Safety Evaluation Report

related to renewal of the
operating license for the
CAVALIER Training Reactor
at the University of Virginia

Docket No. 50-396

May 1985

Figure 3.1 Plans for nuclear reactor facility

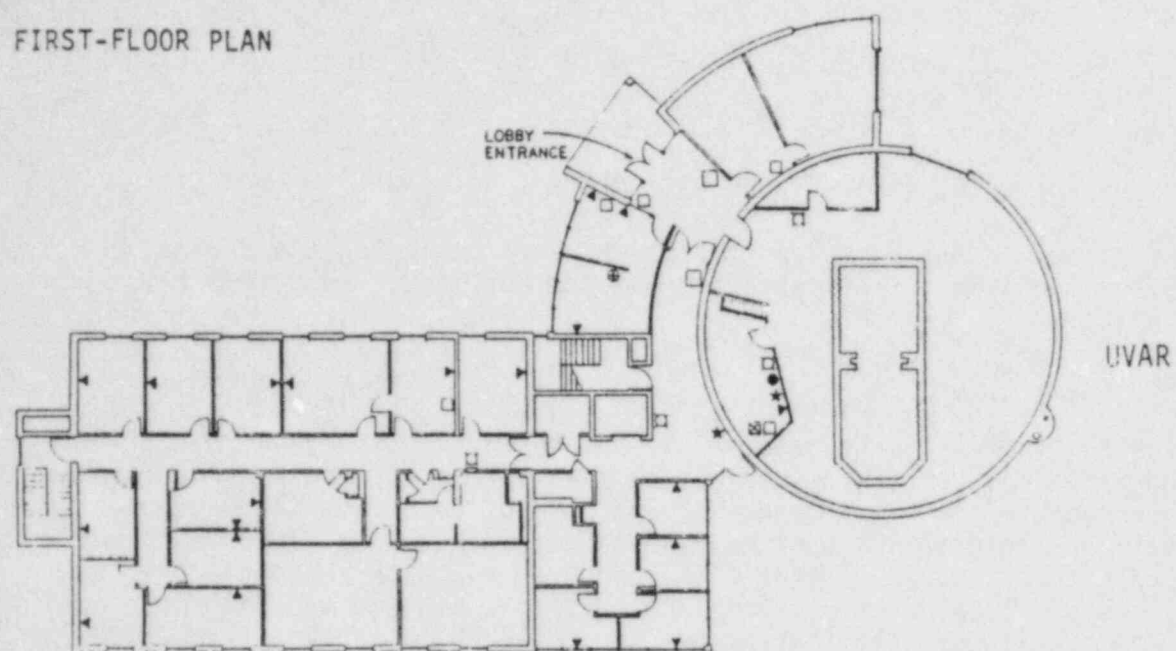
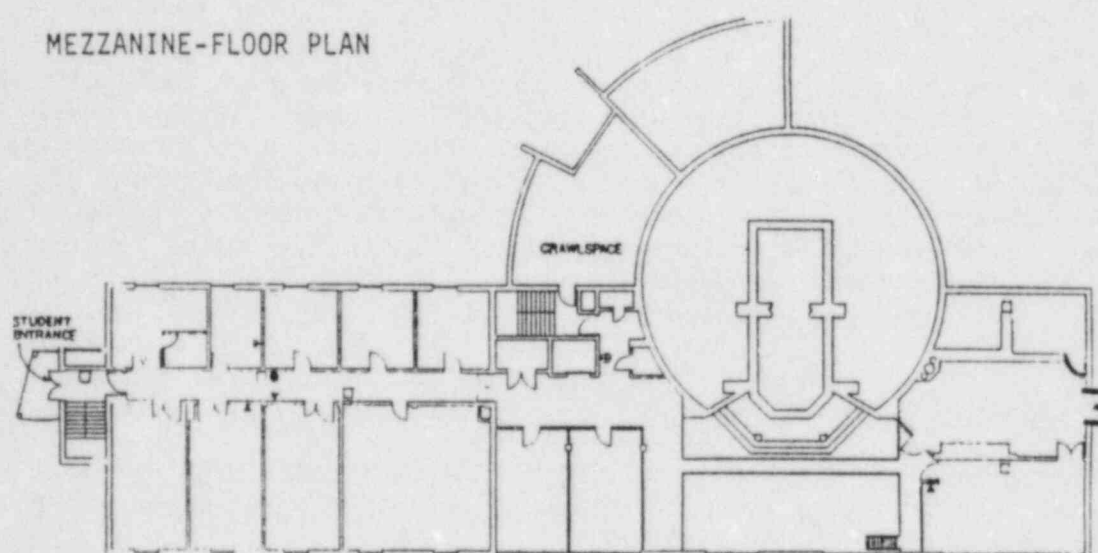
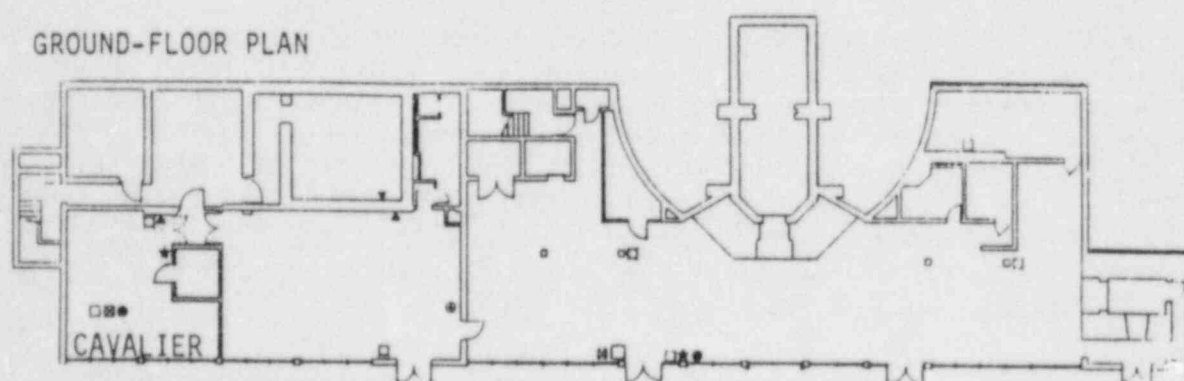
The CAVALIER is located in the reactor wing of the University of Virginia Nuclear Engineering Building, which also houses the UVAR. However, the reactors are in separate rooms and operate independently and no neutronic interaction or hazard coupling between the CAVALIER and the UVAR is considered credible. The reactor facility consists of a main reactor containment room that houses the UVAR, a radiation laboratory, a counting room, an electronic shop, a machine shop, and a student training laboratory that houses the CAVALIER. Figure 3.1 shows the floor plans for the three levels of the reactor facility.

The UVA reactor facility was designed and built to withstand adequately all credible and likely wind, water, and seismic damage associated with the site. On the basis of the considerations above and in Section 14, the staff concludes that damaging natural events have a small likelihood of occurring and small consequences if they did. Therefore, the staff concludes that there is reasonable assurance that natural events at the site do not pose a significant risk to the public from reactor damage.

Figure 4.1 CAVALIER facility details

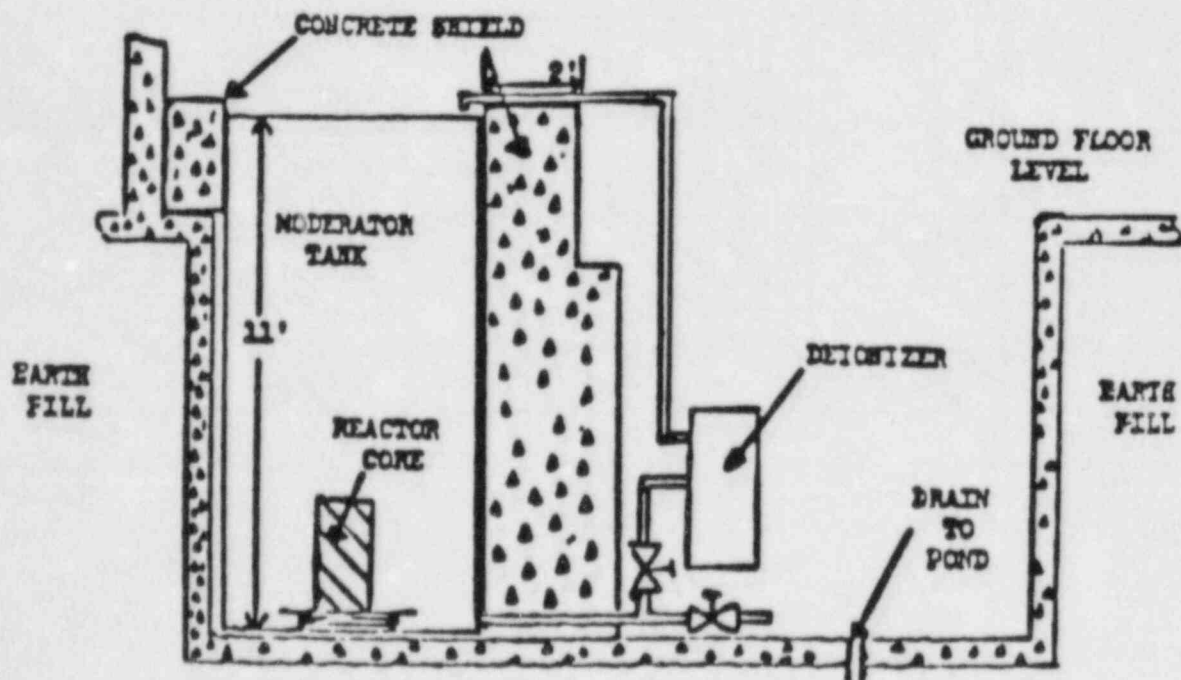
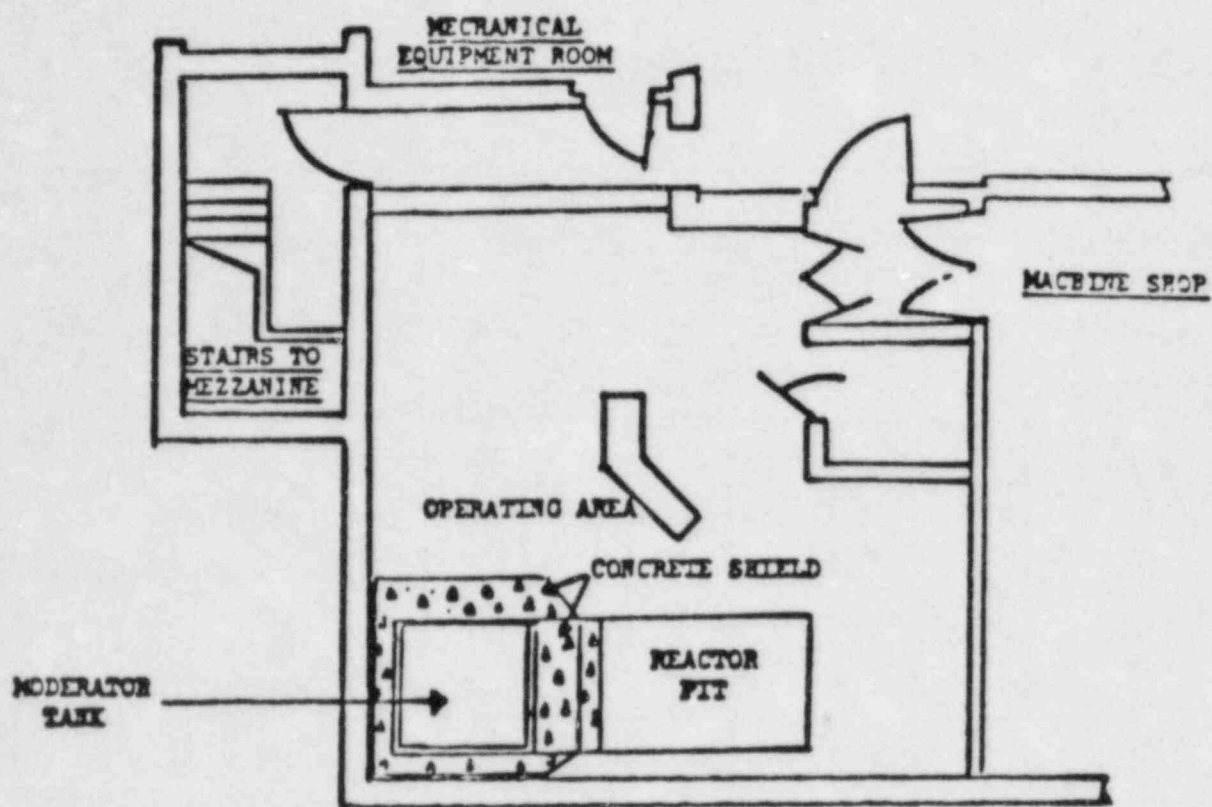
The CAVALIER tank is located inside a 2.74-m-deep concrete pit in the ground floor of the Student Laboratory. An aluminum moderator tank, 1.7 m² and 3.35 m deep, standing 0.91 m above ground level, contains the CAVALIER core and shield water. A cleanup demineralizer for the CAVALIER water also is located in the reactor pit and is separated from the moderator tank by a concrete block wall 0.91 m thick (see Figure 4.1).

The CAVALIER core is submerged in approximately 2000 gal (7572 L) of demineralized water in an aluminum tank and is cooled by natural convection of the bulk coolant. Because of the low power level of the reactor (≤ 100 W), no significant rise in either the fuel or the coolant/moderator temperature occurs as a result of reactor operation, so no heat removal provisions other than evaporation are made. The moderator tank is shown in Figure 4.1.

Figure 4.1 also shows the reactor coolant/moderator purification system. A mixed-bed deionizer using throw-away resins is used to maintain conductivity of the water in the CAVALIER tank at $< 5 \times 10^{-6}$ mhos/cm. The moderator tank water is pumped continuously through the deionizer at ~ 5 gal/min (0.18 L/s). Demineralized makeup water to replace evaporation losses is supplied from the large demineralizer system that serves the UVAR. Discharged resin from the CAVALIER demineralizer is considered as potentially radioactive and is monitored to determine if it must be disposed of as contaminated waste.

Figure 6.1 Alternate reactivity insertion system

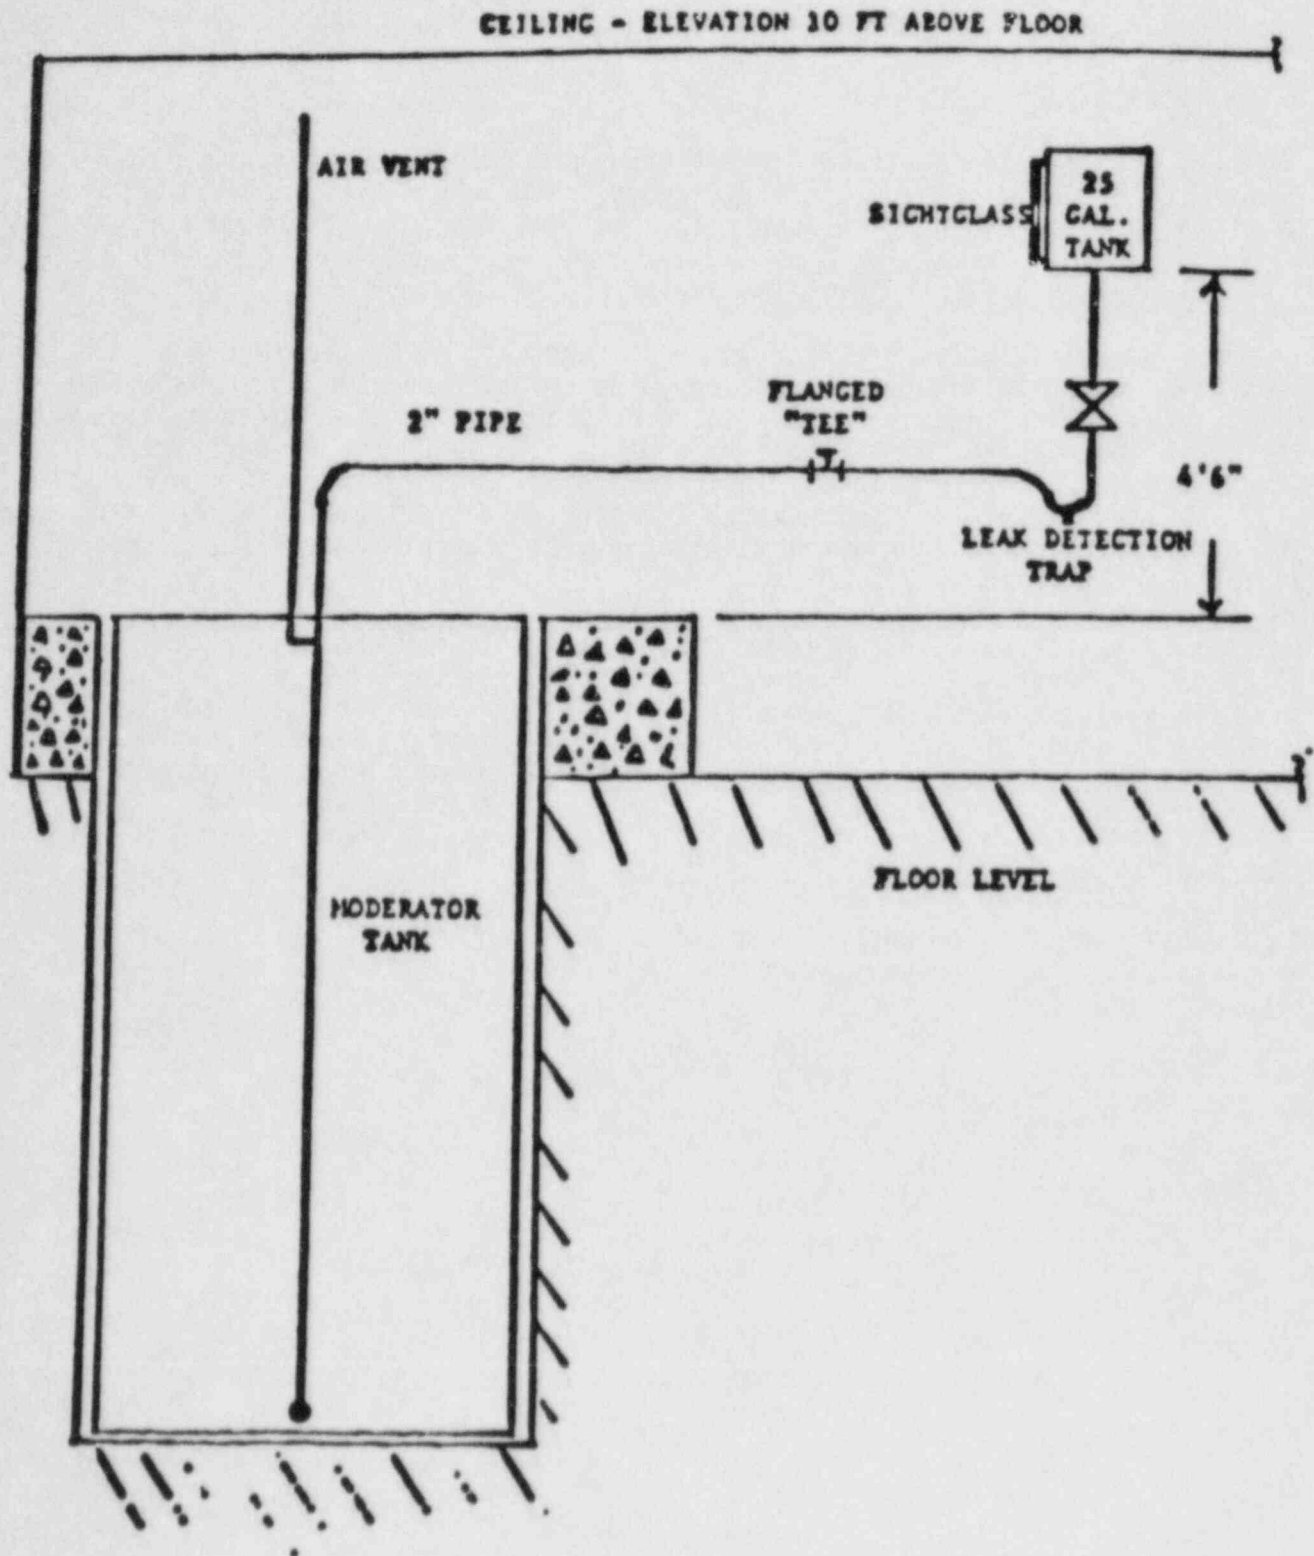
In the very unlikely event that reactor systems fail so that all control rods remain in the fully withdrawn positions, the CAVALIER can be shut down with the ARIS system, which injects borated water by gravity into the moderator tank. The system is composed of a 25-gal tank of borated water connected to the CAVALIER moderator tank with a 2-in. pipe and normally closed with a manually operated valve. The ARIS system is illustrated in Figure 6.1. A leak detection trap in the tank discharge line guards against inadvertent borating of the reactor coolant.

On the basis of its review, the staff concludes that the ARIS would control the total authorized reactivity of the CAVALIER even in the unlikely event hypothesized.

Figure 7.1 Block diagram of CAVALIER safety systems

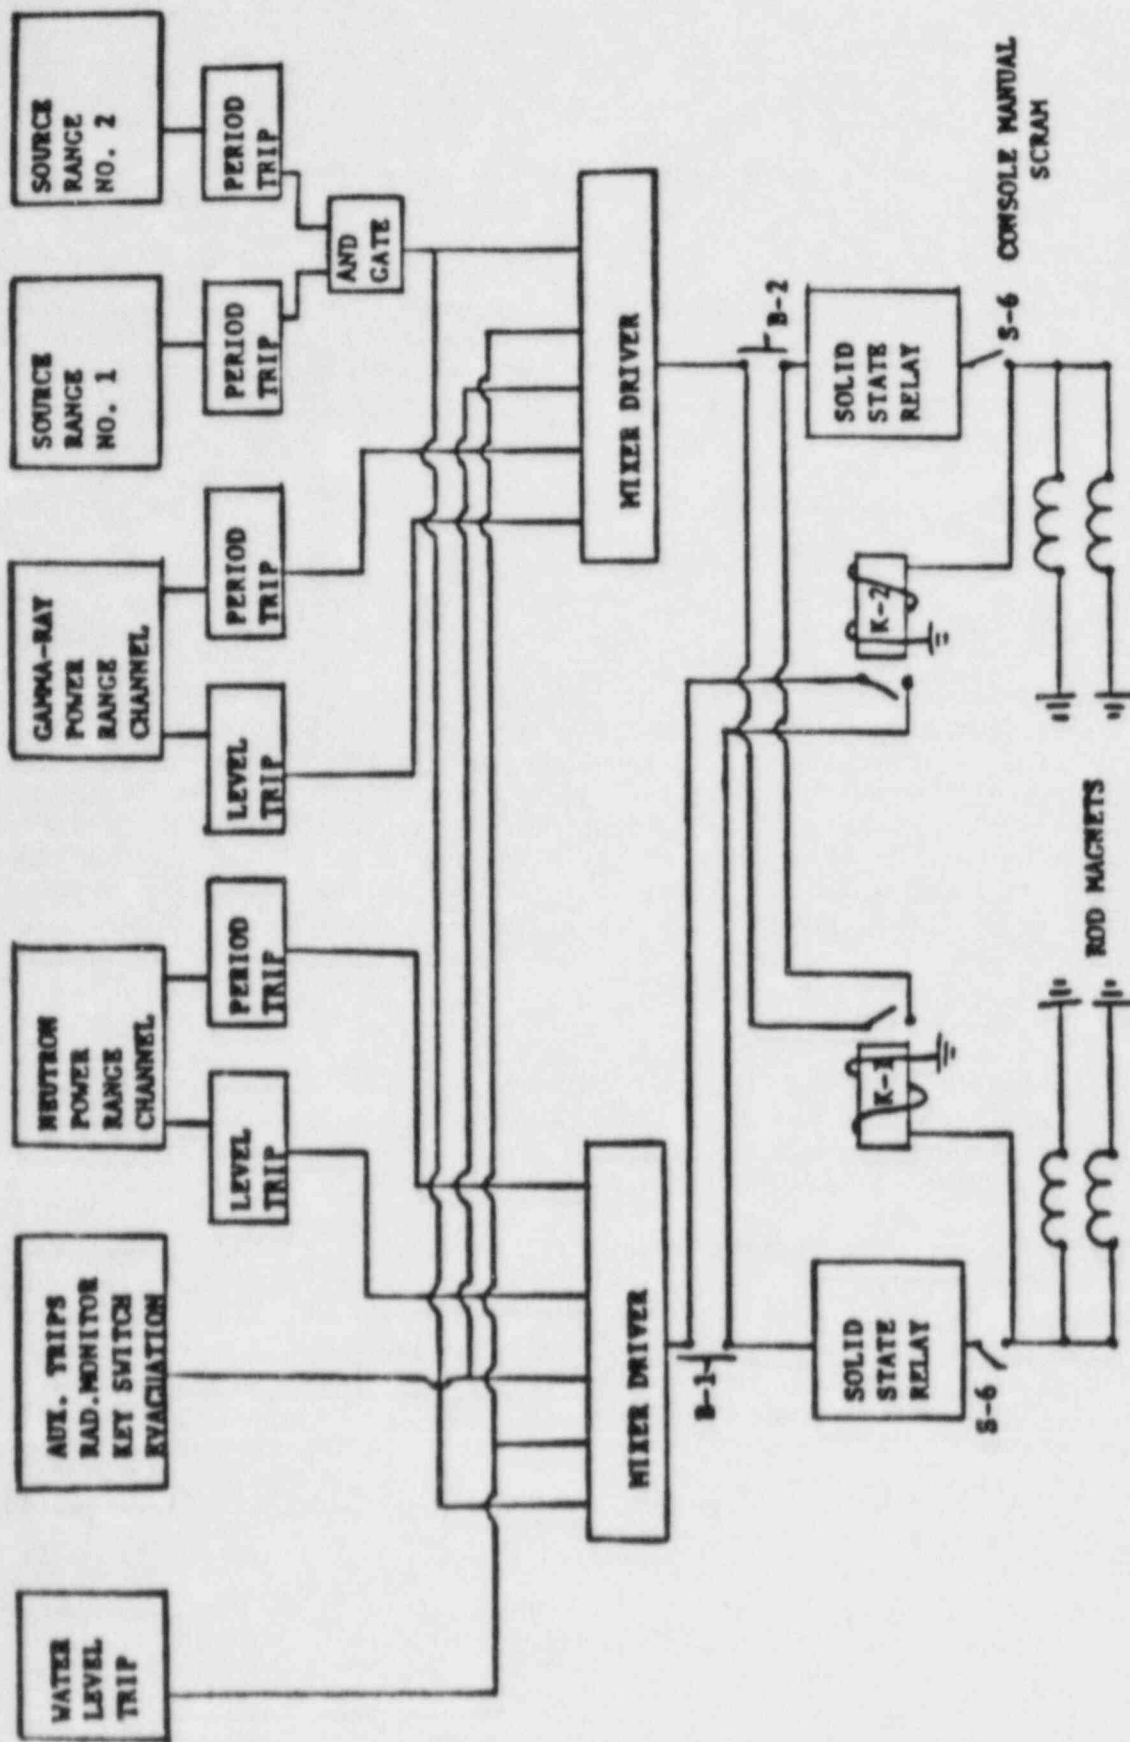
The reactor safety system provides for initiating scrams, controlling rod withdrawal, initiating interlock functions, and supplying signals to the console and annunciator panels. Figure 7.1 shows a block diagram of the CAVALIER safety system.

Scram signals from reactor instrumentation supply signals to two relay systems, each capable of scrambling two control rods with a cross-connect circuit that scrams the remaining two control rods. Thus, the failure of a single component downstream of the mixer-driver will not prevent a reactor shutdown (two rods will still insert). A manual scram deenergizes all four magnetic clutches. For the CAVALIER, any two control rods will add sufficient negative reactivity to make the reactor subcritical.

Figure 7.2 Block diagram of CAVALIER safety channels
 Note: Double lines represent trip signals.

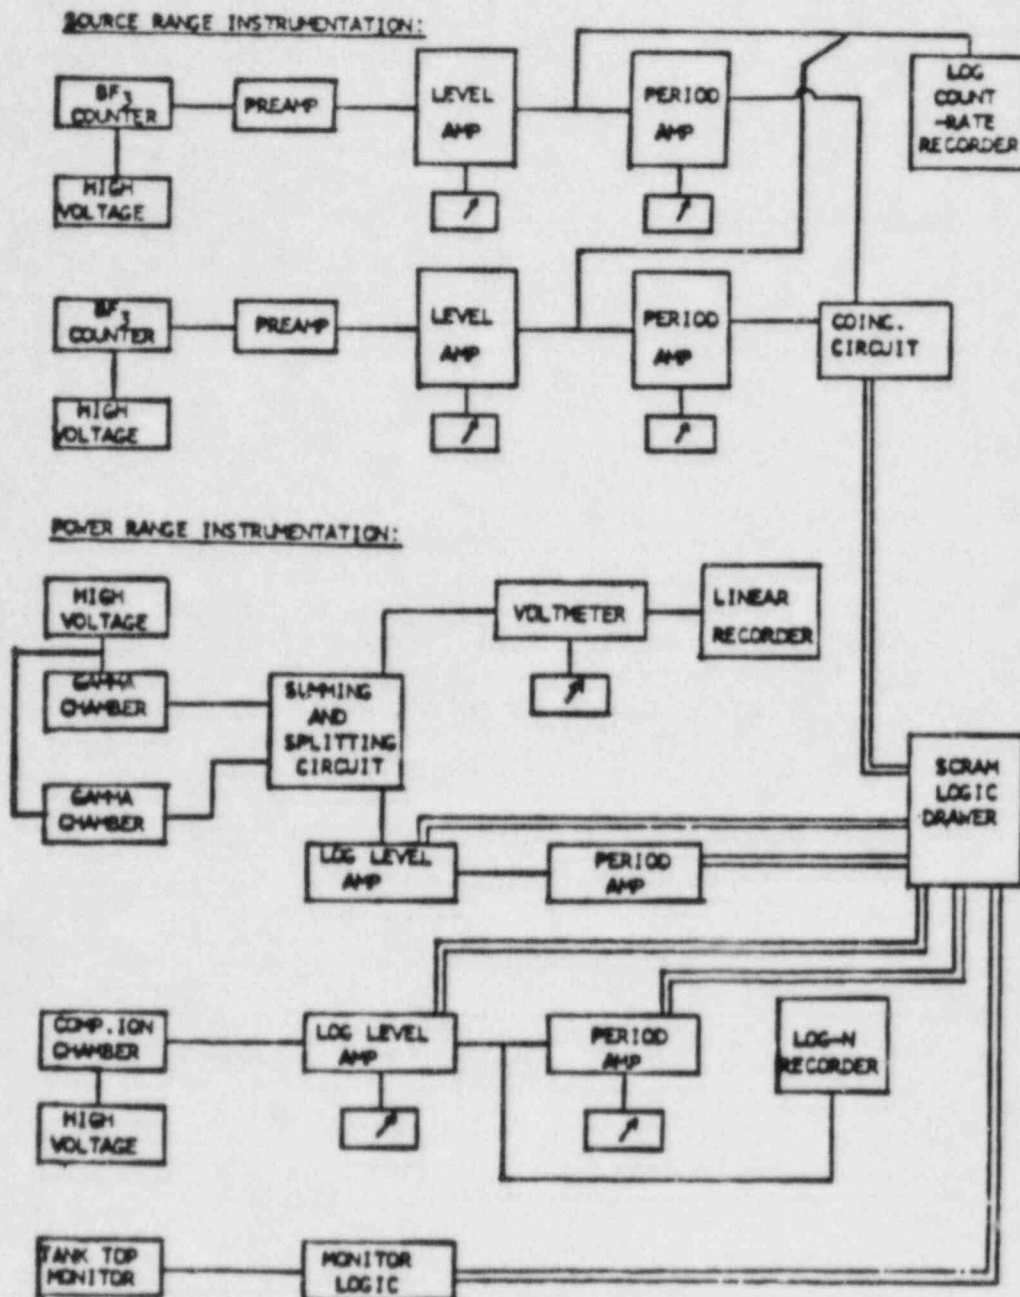
The reactor instrumentation system is fully integrated with the reactor safety system (rod control and scrams) to comprise a single integrated system. Both nuclear and nonnuclear parameters are measured and monitored by the system. The CAVALIER Technical Specifications require a minimum number of safety channels (listed in Table 7.1) for reactor operation. The CAVALIER instrumentation is designed to operate over two ranges of reactor power, source range and power range. Figure 7.2 provides a block diagram of the reactor safety system instrumentation.

The control and instrumentation systems at the CAVALIER are well designed and provide for flexibility and reliability. There is sufficient redundancy and diversity in the major nuclear instrumentation and, in particular, the nuclear power measurements that are overlapped in the ranges of the startup, log-N, and linear power level channels. Additionally, the control system is designed to shut down the reactor automatically if electrical power is lost. The reactor scram system is designed so that a single component failure will not prevent shutdown.
